Proposed Change 1812

Code Reference(s):	NBC20 Div.A 1.3.3. (first printing)
Subject:	Alteration of Existing Buildings
Title:	Application of NBC Part 10 to the Alteration of Existing Buildings
Description:	This proposed change states the application of proposed NBC Part 10 to the alteration of existing buildings.
Related Proposed Change(s):	PCF 1813, PCF 1824, PCF 1839

Figure ~~[A-9.36.2.5.(3)-A]~~ A-9.36.2.5.(3)-A
Masonry fireplace insulated within itself

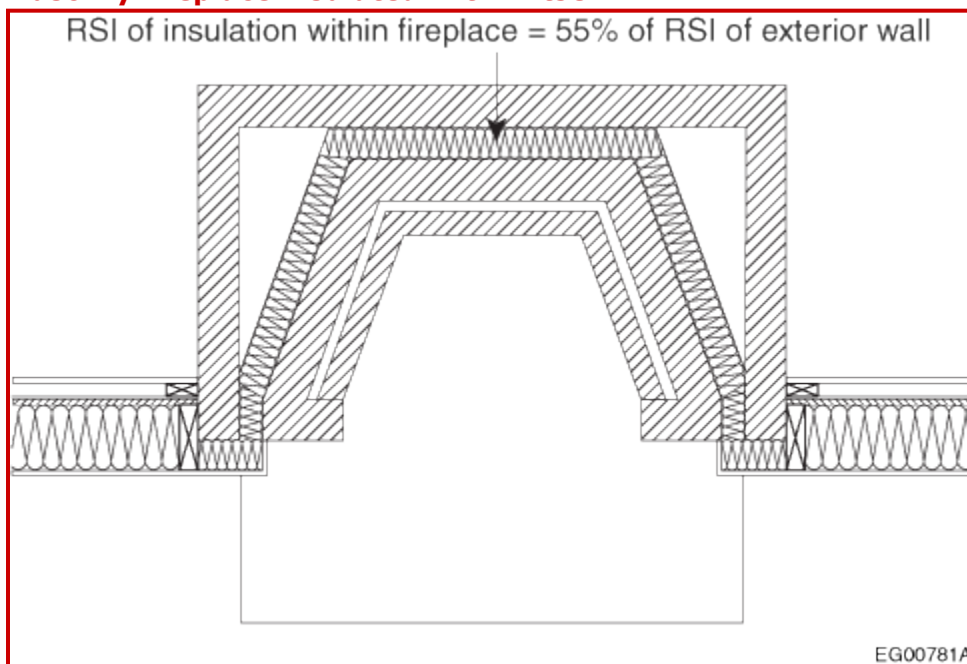
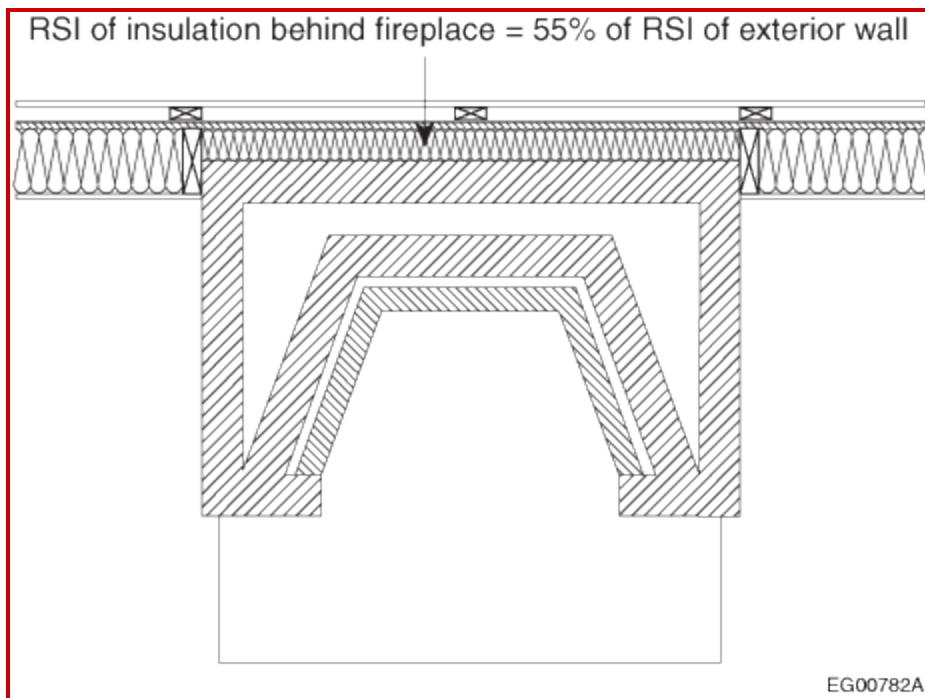
[3] 3) Where a masonry fireplace or flue penetrates an exterior wall and breaks the continuity of the plane of insulation, ~~the fireplace or flue shall it shall be insulated within the plane of insulation of the wall or within itself to an effective thermal resistance not less than 55% of that required for the exterior wall as stated in Table 9.36.2.6.-A or 9.36.2.6.-B (See Note A-9.36.2.5.(3).)~~

The two insulation options for masonry fireplaces and flues presented in Sentence 9.36.2.5.(3) are consistent with those presented in Sentences 9.36.2.5.(2) and (4) with the exception of the option to insulate the sides of the penetrating element to 4 times the thickness of the penetrated wall, which would not be an energy-efficient option in cases where the penetration by the fireplace or flue is several feet wide. Figures A-9.36.2.5.(3)-A and A-9.36.2.5.(3)-B illustrate the options for achieving a continuously insulated exterior wall where it is penetrated by a masonry fireplace or flue.

Figure [A-3.1.1.6.(2)-2025]

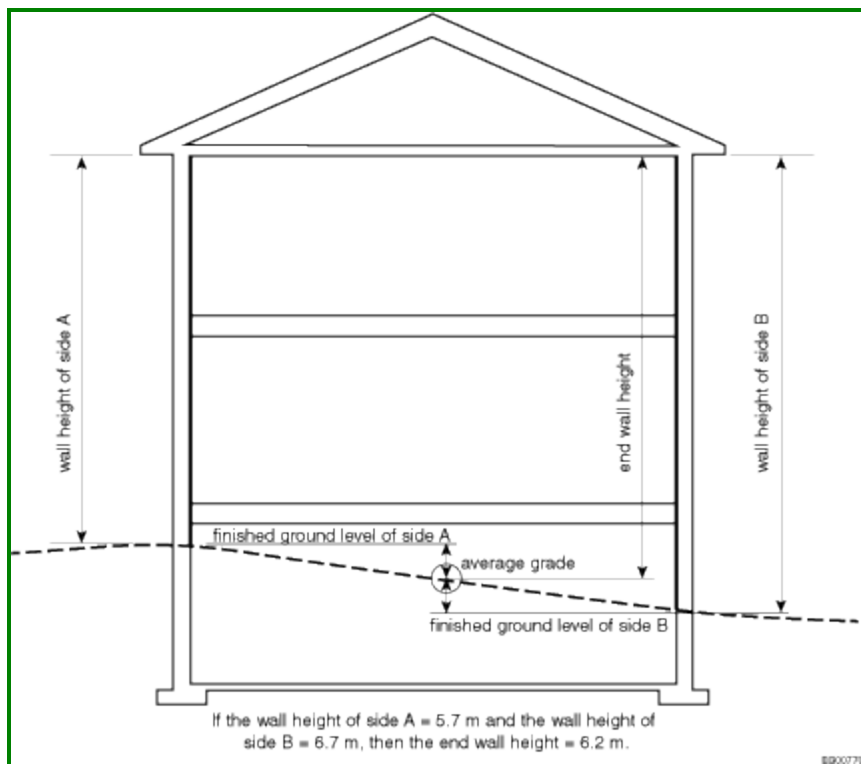
Where the structure of the lowest floor and rim joist assembly is above the finished ground level or where the above-grade portion of foundation walls separates conditioned space from unconditioned space, they should be included in the calculation of gross wall area. Figure A-3.1.1.6.(2) shows the intended measurements for the most common type of housing construction.

Figure [A-3.1.1.6.(42)] A-3.1.1.6.(2)
Measuring areas of glazing that is not in the same plane

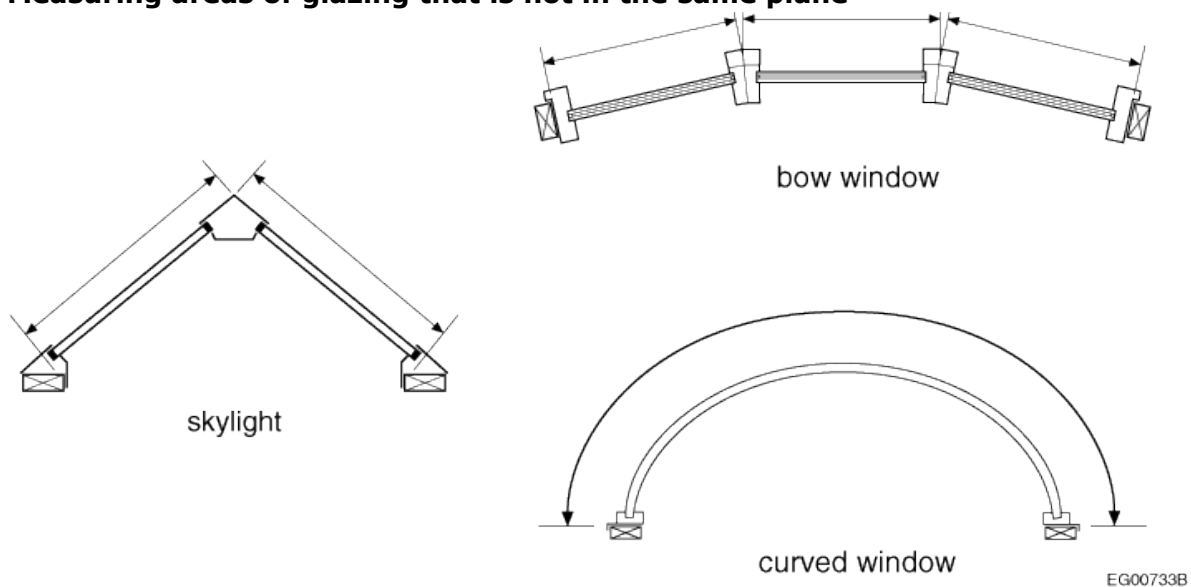
- [4] 2)** The *fenestration* area made of flat panes that are not all in the same plane or curved panes shall be measured along the surface of the glass. (See Note A-3.1.1.6.(42) ~~Note A-3.1.1.6.(2).~~)

Figure A-3.1.1.6.(2) illustrates how to measure the area of glass panes as described in Sentence 3.1.1.6.(2).
